Flight Procedures Cover Page	Task Action: FLIGHT CHECK	Task Type: SID	Estimated Chart Date: 05/14/2026	APWS Task ID: C9C66A03695B4BC9A212B75C06CF607E	APWS Project ID: 22EA0654BB1F4F148F1F10A92F124413
Procedure: MAREO ONE (RNAV)	Enroute: YES	Specialist: Dudzinski, Lisa	Agreement Number:		
Airport ID: KIND	Airport City: INDIANAPOLIS	State: IN			
Facility ID:	Facility Type:	Flight Inspection Remark Type: New FC Slot

PROCEDURE: MAREO ONE DEPARTURE (RNAV)		AIRPORT NAME: INDIANAPOLIS INTL		AIRPORT ID: KIND	SPECIAL CONTROL NO: BG-01-153-26
FAC ID: MAREO1		CITY: INDIANAPOLIS		ST: IN	ORIG CHART DATE: 05/14/2026
DFL TYPE: PROC/D	THIRD PARTY: <input type="checkbox"/> YES	EST. TIME ON SITE: 1.0	REIMB. NUMBER: AC0721	PTS TASK ID: C9C66A03695B4BC9A212B75C06CF607E

(MAREO1.MAREO) FIG
MAREO ONE DEPARTURE (RNAV)

PRB RESULT: RETURN FOR REWORK

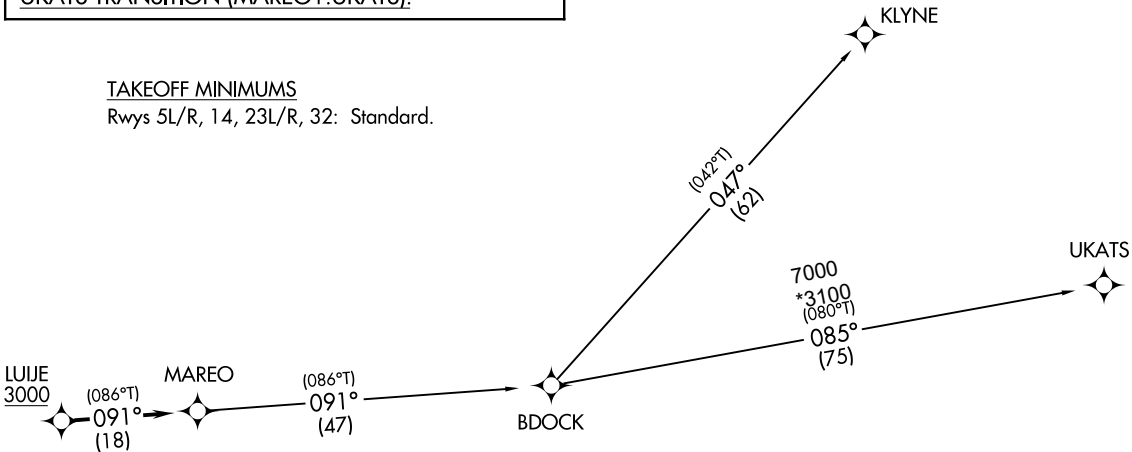
1. THE ENROUTE (LAST LEG) OF THE PROPOSED SID_BDOCK TO UKATS SHOULD HAVE THE MOCA CHARTED. SEE 8260.46K, PARAGRAPH 3-1-1.J.(2)(B) FOR MOCA GUIDANCE.

- COMPLETE -I HAVE PDF EDITED THE FIG TO SHOW THE MOCA/MEA.
